Staff Report for Planning Board

Meeting on September 17, 2025
Project Summary – Minor Site Plan

Project: Enterprise Mobility (2025-104)
Property Owner: Skuffy's LLC
Applicant: Northpoint Engineering, LLC
Project Address: 28 Manchester Street
Tax Map Lot: 781Z 31

TO: Alec Bass, Assistant City Planner
FROM: Paul Gildersleeve, PE and Pete Kohalmi, PE
DATE: September 4, 2025
SUBJECT: Enterprise Mobility- Minor Site Plan – Engineering Review
28 Manchester Street; Map 781Z, Lot 31; City Project 2025-104

The image below shows the proposed grading and drainage plan (red) overlaid on top of the grading plan from Case 2003-079, titled "Enterprise Rent-A-Car," prepared by Sublime Civil Consultants, Inc, dated August 21, 2003, with revisions through March 16, 2004. (black)

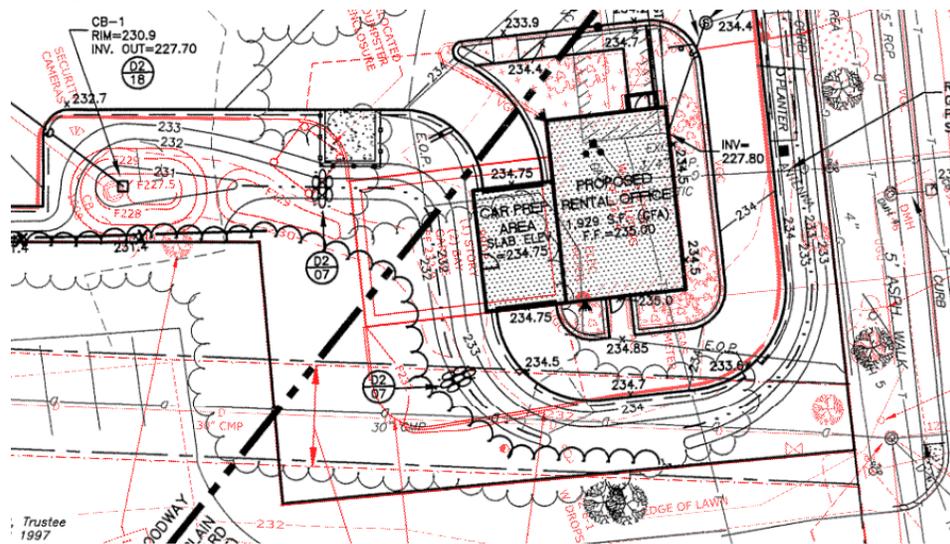
- 16.02(12)(a) Requires all swales, drainage ditches, culverts, drain pipes, inlet and outlet structures, catch basins and manholes, easements, stormwater treatment structures, and detention and retention ponds shall be shown on the plan, including such elevations and cross-sections as may be necessary to determine the suitability and adequacy of the proposed system. The applicant has provided with the plan set on sheet 4, a grading and drainage plan. However, the expansion of the garage protrudes across the existing drainage swale approved as part of Case 2003-079, and does not appear to account for drainage collected from that drainage swale which will be now blocked by the expansion of the garage. Additionally, the grading plan shows a 232-foot contour elevation at the southeast corner of the garage proposed to have a 232.9-foot finished floor elevation, and does not consider the grading necessary for the construction of the relocated dumpster pad, or grades directly adjacent to the building. Accordingly, additional contours and spot elevations shall be added to the grading plan to more clearly demonstrate the intended grading at the following locations: spot elevations at the four corners of the relocated dumpster pad and contours showing grading away from said pad; additional contours and spot

elevations showing proper grading away from the building in the new drainage swale; additional contours or spot elevations showing intended grading at the southeast corner of proposed garage; and, additional contours to show the existing remaining drainage swale along the eastern side of the site, as well as new grading contours showing how this swale will be carried around the expanded garage and driveway.

- n. Provide on sheet 3 a tabulation for the number of required trees, and number of trees being provided. (Section 15.04(28)(o))
 - o. Additional contours and spot elevations shall be added to the grading plan to more clearly demonstrate the intended grading at the following locations: spot elevations at the four corners of the relocated dumpster pad and contours showing grading away from said pad; additional contours and spot elevations showing proper grading away from the building in the new drainage swale; additional contours or spot elevations showing intended grading at the southeast corner of proposed garage; and, additional contours which show the existing remaining drainage swale along the eastern side of the site, as well as new grading contours showing how this swale will be carried around the expanded garage and driveway. (Section 16.02(12)(a))

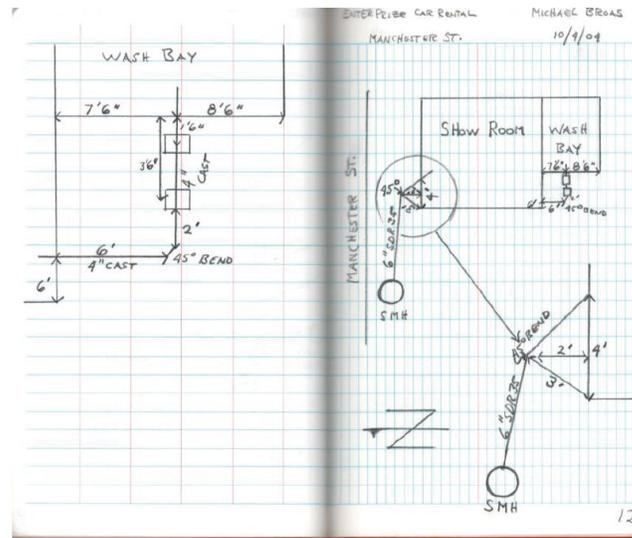
- 16.02(14)(a) Requires showing on the utility plan, the location, size, and type of any other appurtenant facilities or structures associated with the provision of potable water supply and sanitary waste disposal. Staff notes that sheet 4 also shows the location of municipal and nonmunicipal utility services, and shall be relabeled as "Grading, Drainage, & Utilities Plan." Additionally, staff notes that the applicant has shown the sanitary sewer service entering on the western side of the building. According to a City sanitary sewer service record, dated October 4, 2004, the service appears to enter on the northern side of the building, and also includes the location of the service exiting the south side of the office building and then entering the western side of the garage building. Unless if upon review the applicant has additional information to the contrary, the location of the sanitary sewer service and fixtures shall be revised based on the City's record of sanitary service. Special attention shall be made to the service exiting the southern side of the building, as this service and fixtures, may be impacted during the construction of the proposed garage.

- p. Sheet 4 shall be relabeled as “Grading, Drainage, & Utilities Plan”. Additionally, unless if upon review the applicant has additional information to the contrary, the location of the sanitary sewer service and fixtures provided on sheet 4 shall be revised based on the City’s record of sanitary service records. (Section 16.02(14)(a))
